Product / Process Change Notification (PCN)

PCN Number: PCN_ConPSHD_20240917

Affected Series: WR-PSHD

Packaging Specification - Tape and Reel: [mm]

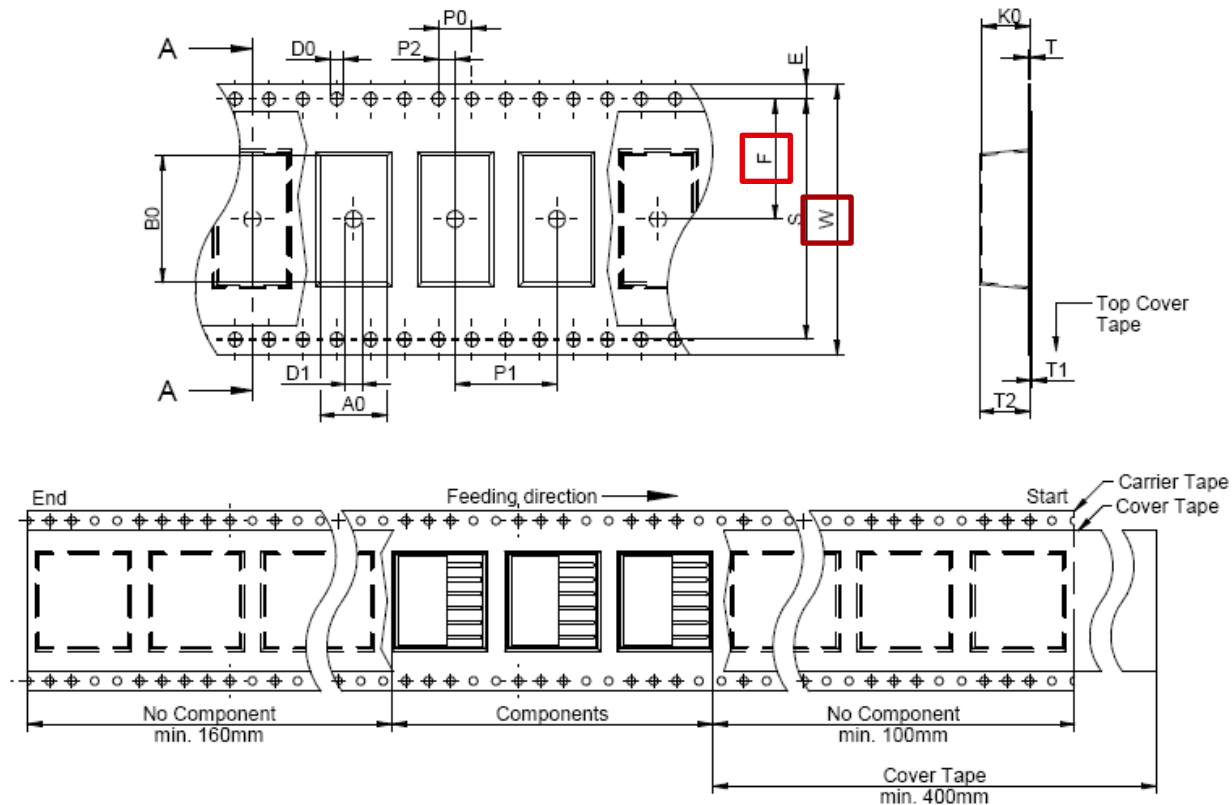
Due to packaging optimizations, Würth Elektronik eiSos will update tape & reel size, implying carton quantity changes.

Before	After
W (mm)	32	44
F (mm)	14.2	20.2
Reels / carton	7	5
Quantity / carton	3500	2500
